E4432B-11**S E R V I C E N O T E**Supersedes:
NONE**ESG “B” Signal Generator E4432B**

Defective Waveform Sequence SRAM on the Dual Arbitrary, UND board (A5) and iDEN Dual Arbitrary, Special Option H60 board causes waveform become distorted when playback.**To Be Performed By: Agilent-Qualified Personnel****Parts Required:**

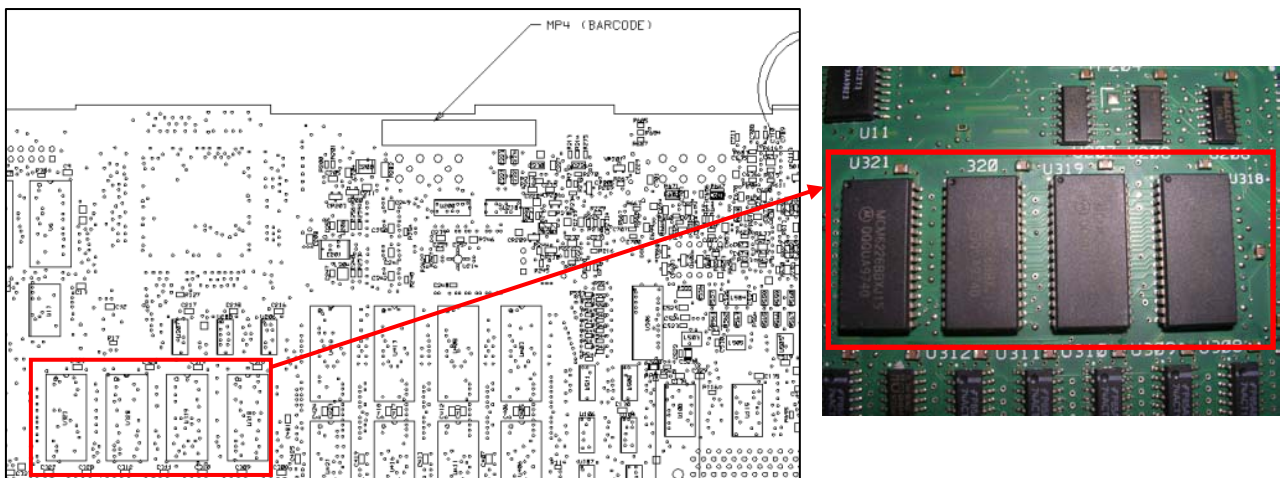
The ESG-B D/DP Family of Signal Generators has been experiencing failures in the UND (E4400-60187) and Option H60 (E4400-60186) board assemblies. This is due to a failure of the waveform sequence SRAM ICs. There are total 4 affected waveform sequence SRAM ICs on the UND and Option H60 assembly, designator U318, U319, U320, U321. The failure will cause the waveform playback become distorted. This may happen immediately after Arbitrary Function is turned on, or after it has been play-backed for a short period of time. This potentially happened when large waveform files are being playback. All ESG-B D/DP units with the symptoms mentioned above required the waveform sequence memory chips to be replaced. The kit, E4400-60753 contains 4 pieces of the SRAM ICs.

1. Repair on failure.
2. Prevent future occurrences due to a defective waveform sequence memory chips (U318, U319, U320, U321) by replacing the 4 affected chips.
3. Locate the U318, U319, U320 and U321 which are located at the bottom side of the UND or H60 board.

4. Replaced the affected components. **Caution:** Please use the appropriate soldering tools and you must be certified to perform the soldering to prevent any quality or reliability issue due to soldering workmanship.
5. Once the affected components had been replaced, perform:-
 - i) Dual Arb Waveform Generator Check. This test can be performed by using the TME software or the ESG-B Classics Software, and
 - ii) If customer waveform is stored in the NVARB RAM, playback the waveform and observed on the oscilloscope for any waveform distortion.
